**PA-2017-00978**  
**232 Nutley**

**Packet information submitted at the  
October 10, 2017 PC Meeting**

**PLANNING ACTION:** PA-2017-00978

**ASHLAND PLANNING DEPARTMENT  
STAFF REPORT**

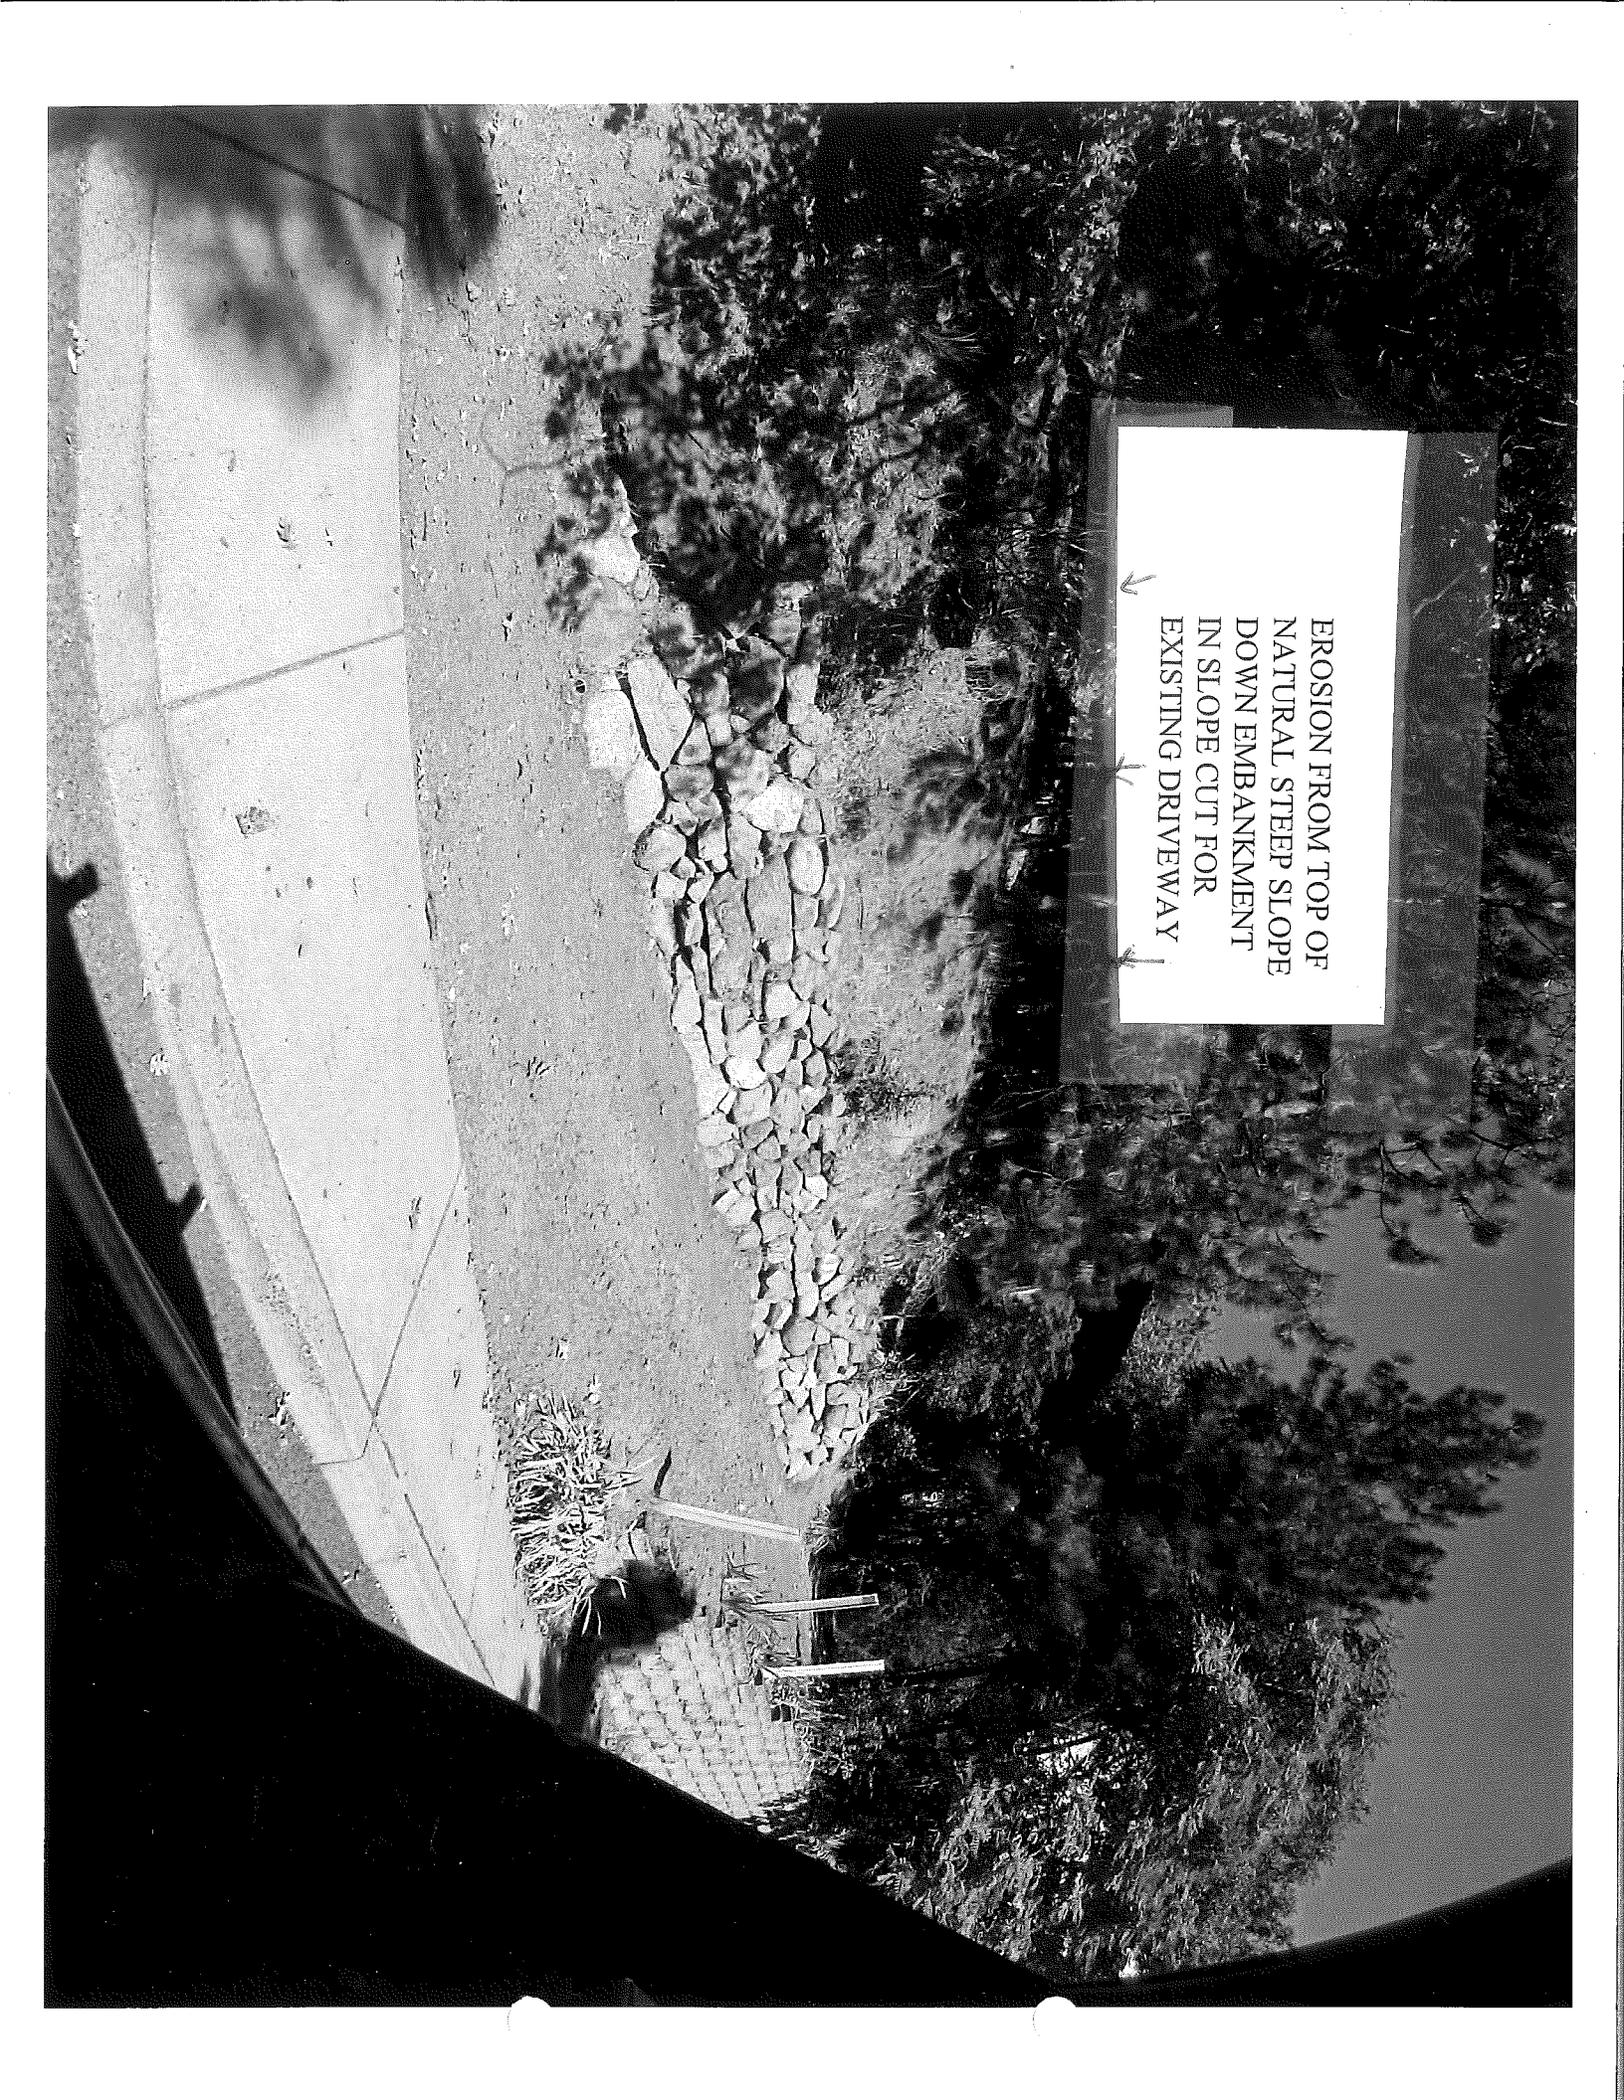
WOOD STRUCTURE  
(PLAYHOUSE) DETACHED  
WITH WINDOWS,  
STAIRS TO ENTRY DOOR,  
ROOF TOP DECK WITH  
RAILING →

A "PARKING  
SPACE" WITH  
NO WHERE  
TO GO

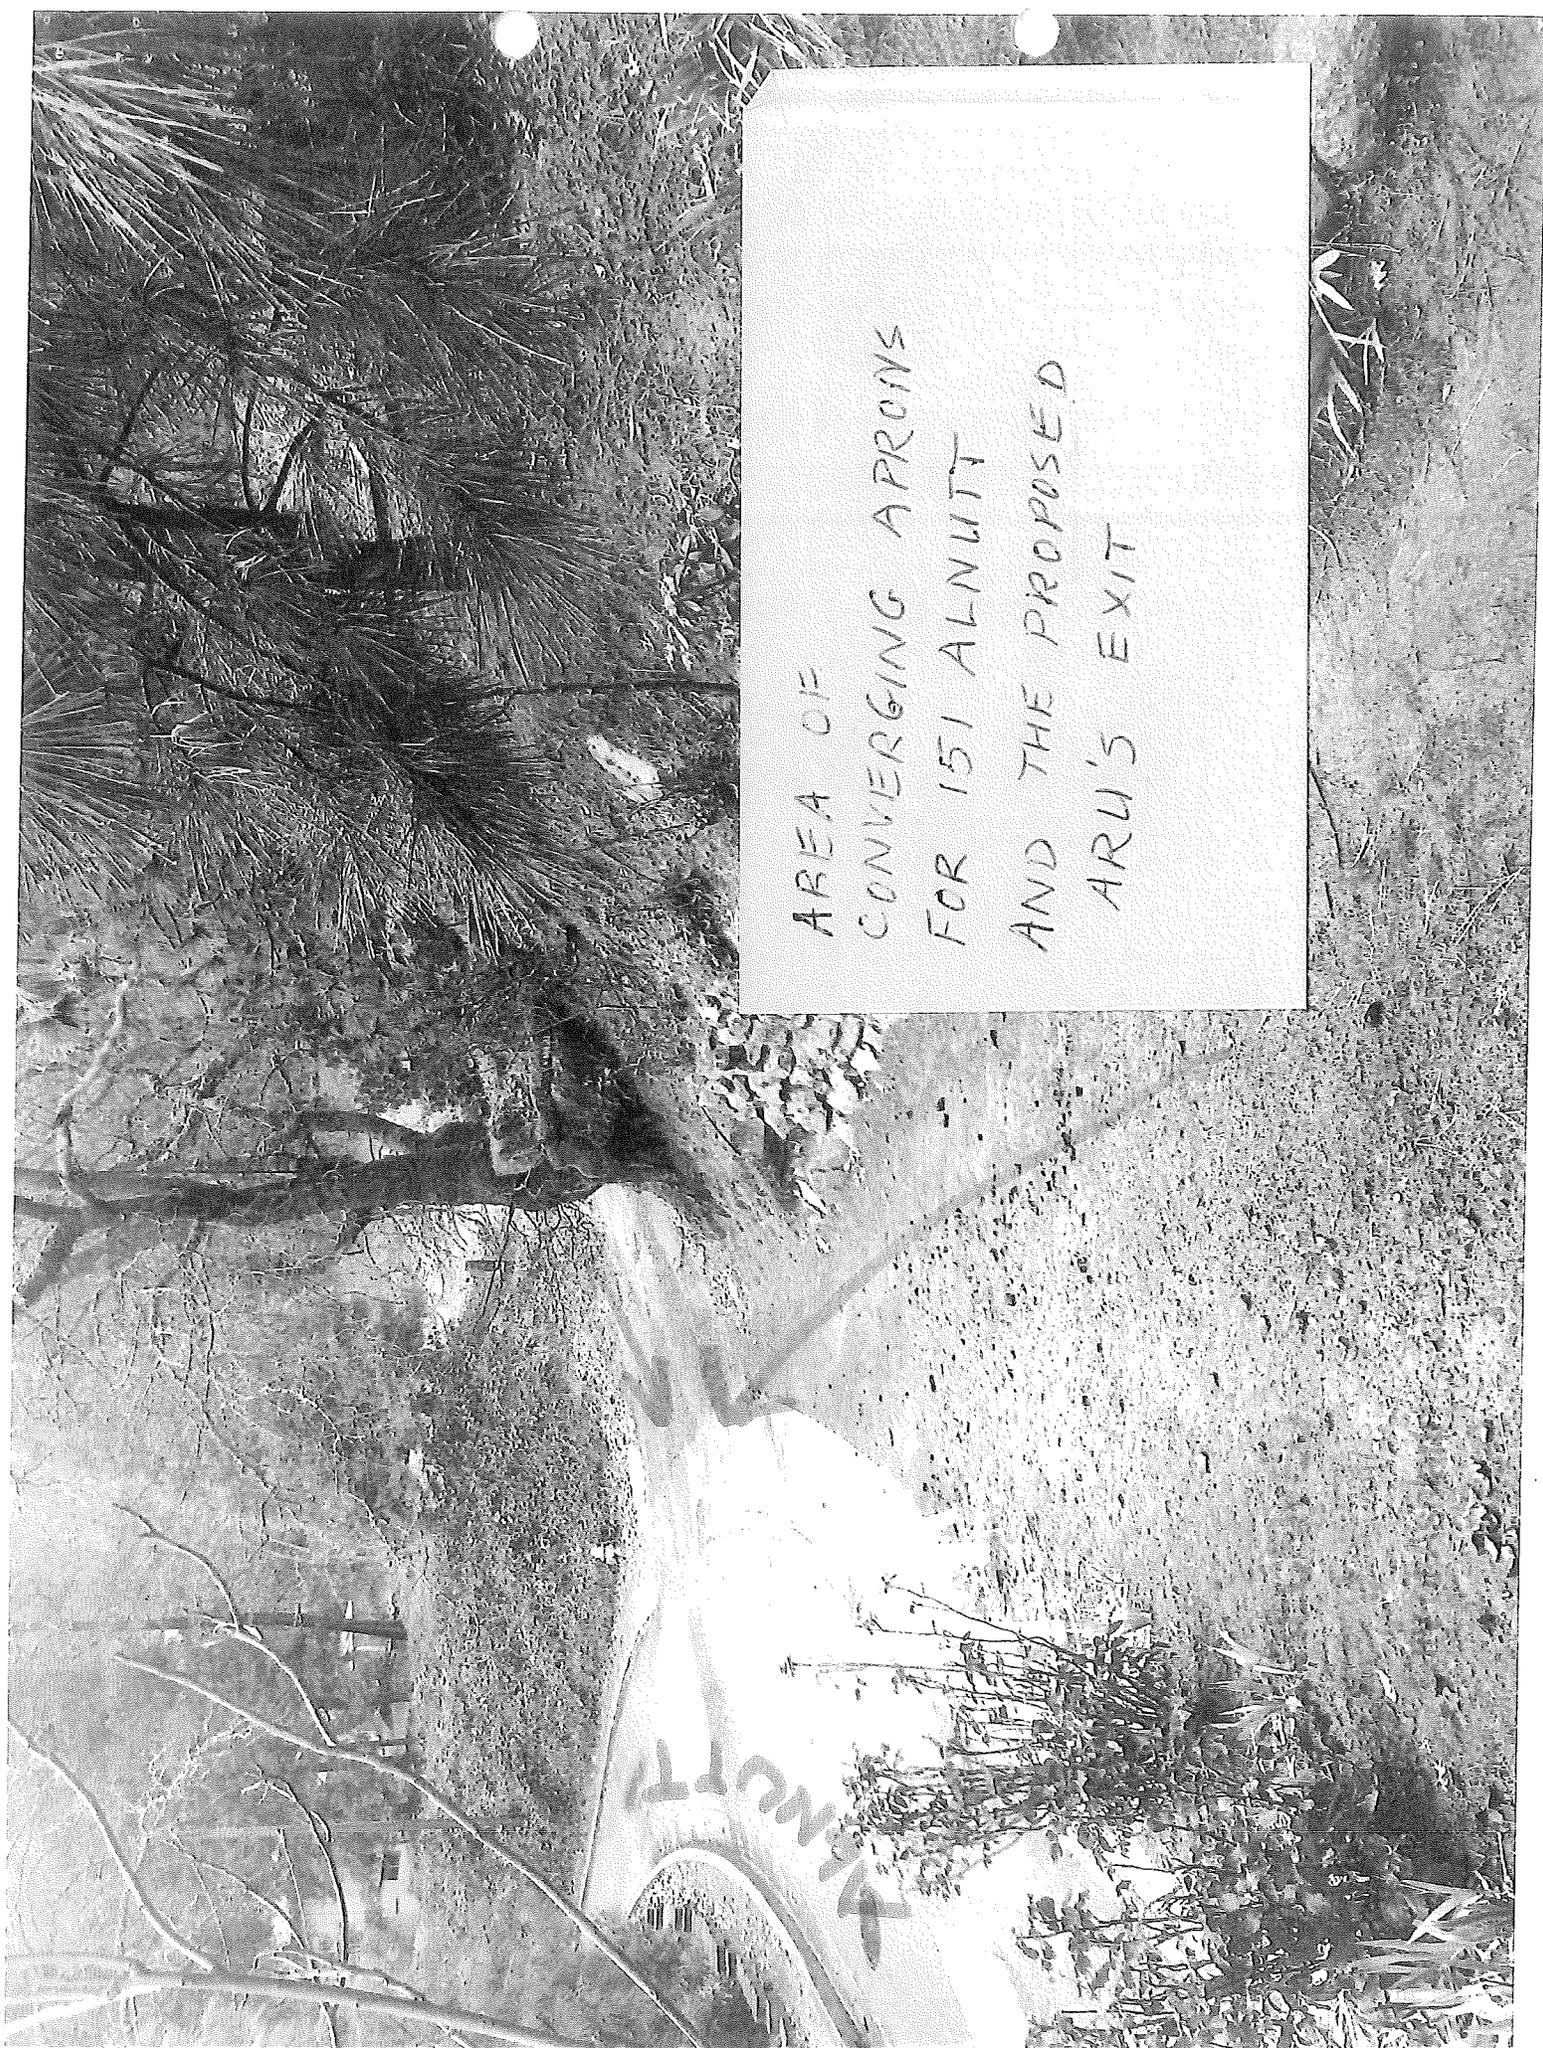
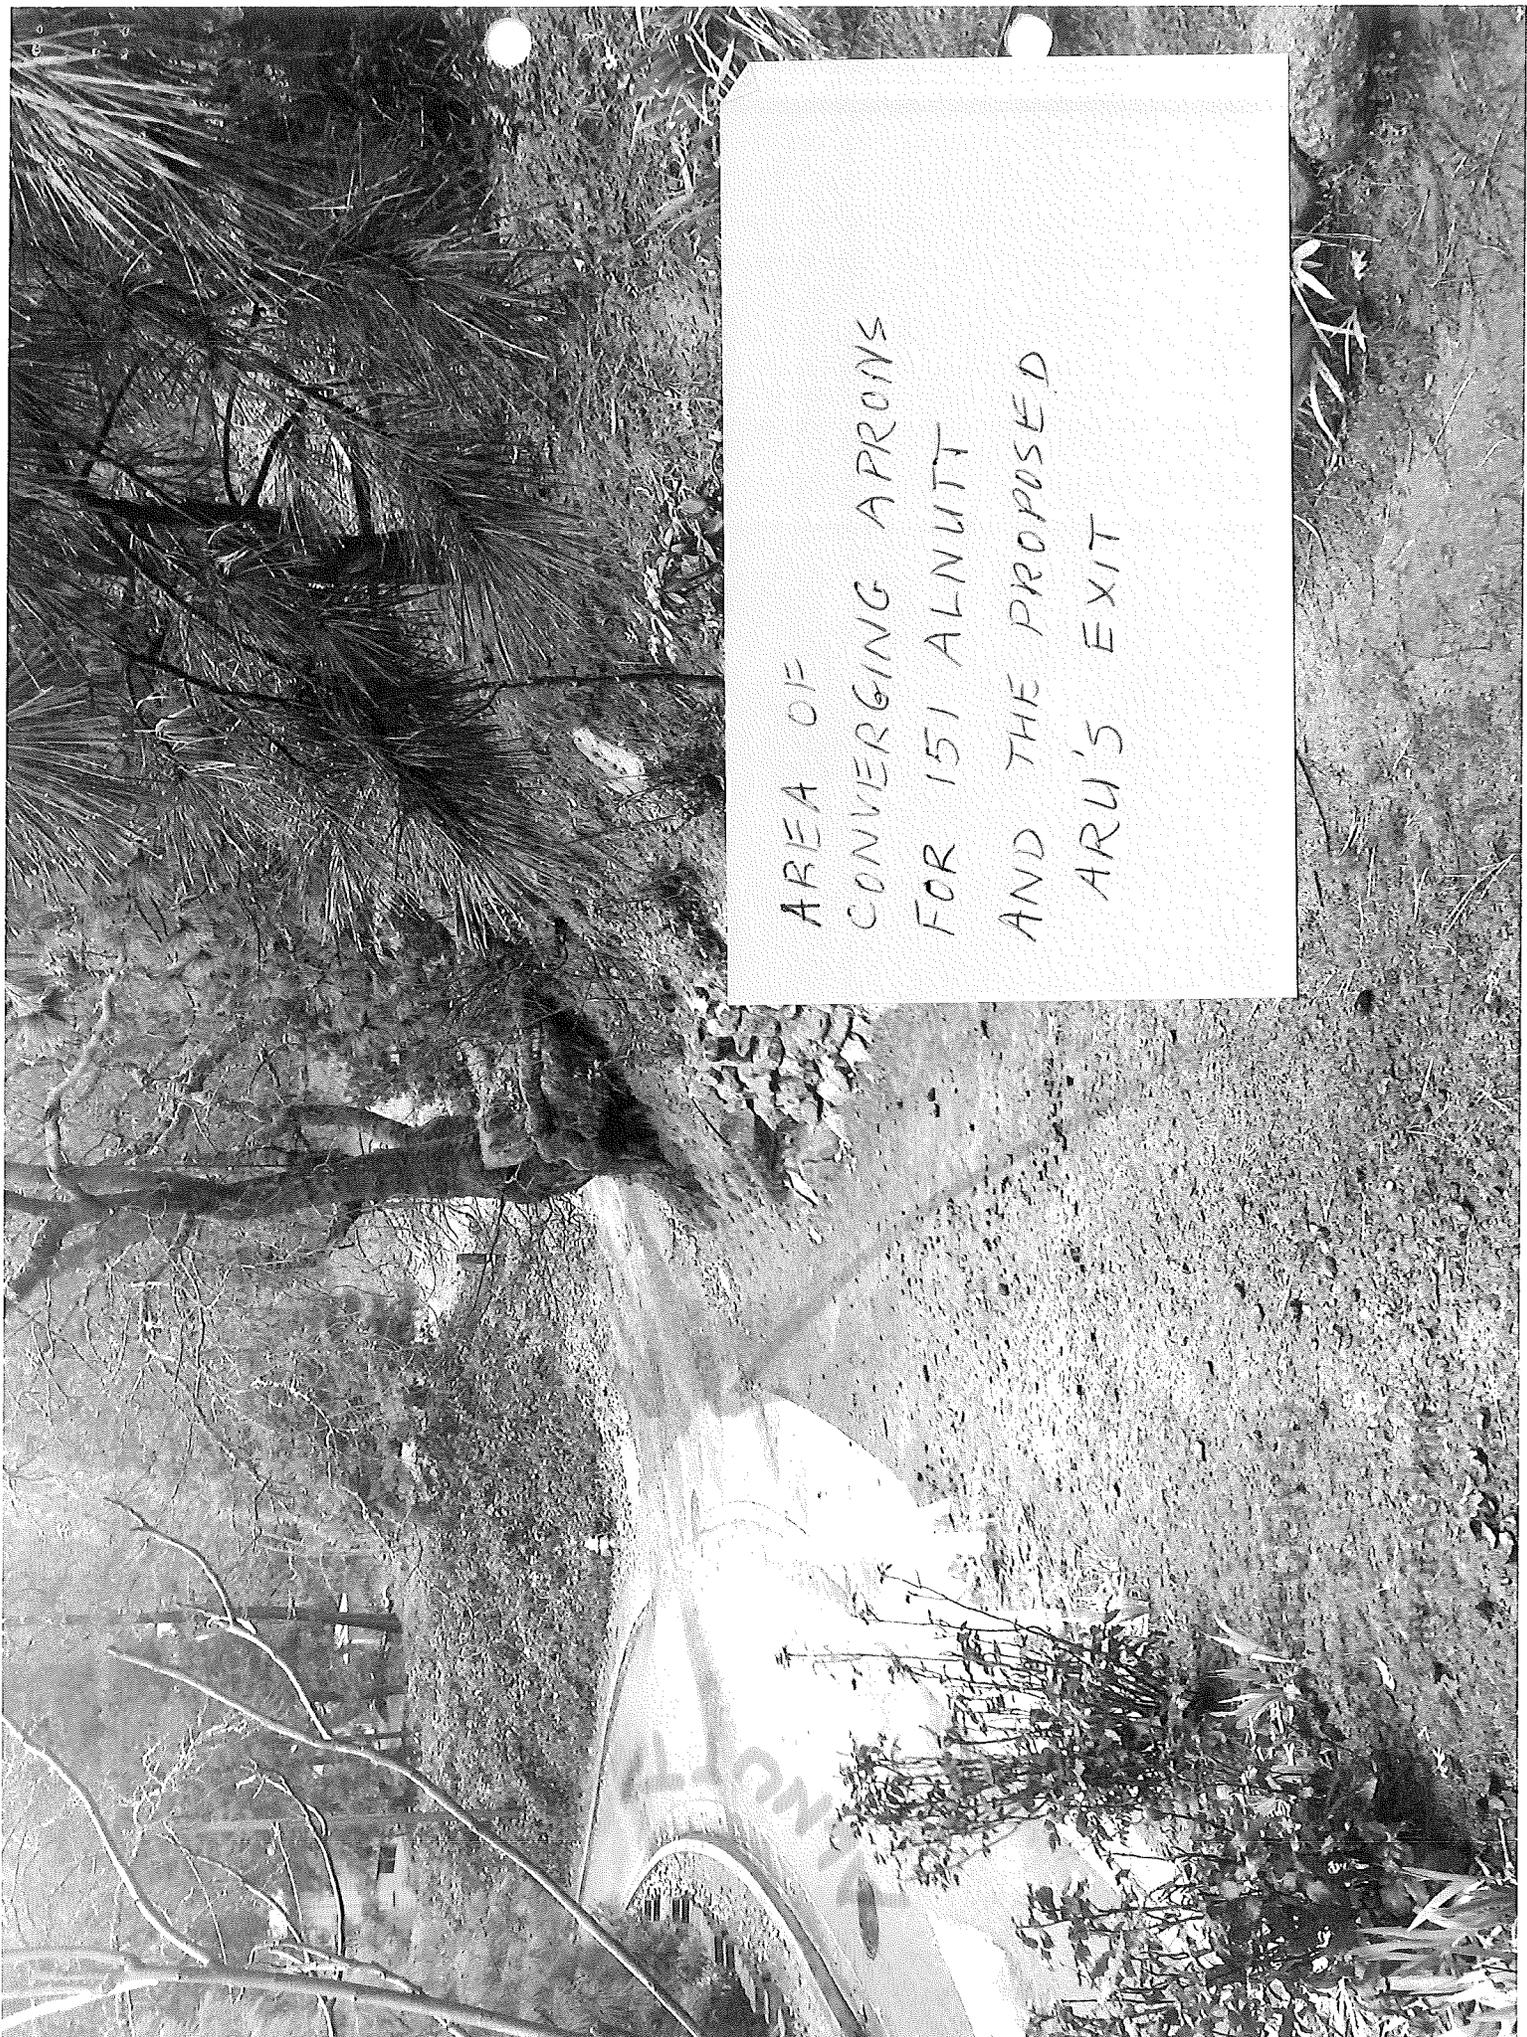
AREA OF  
CONVERGING APRONS  
FOR 151 ALNUTY  
AND THE PROPOSED  
ARU'S EXIT

AREA OF  
CONVERGING APRONS  
FOR 151 ALNUTT  
AND THE PROPOSED  
ARU'S EXIT

A "PARKING  
SPACE" WITH  
NO WHERE  
TO GO
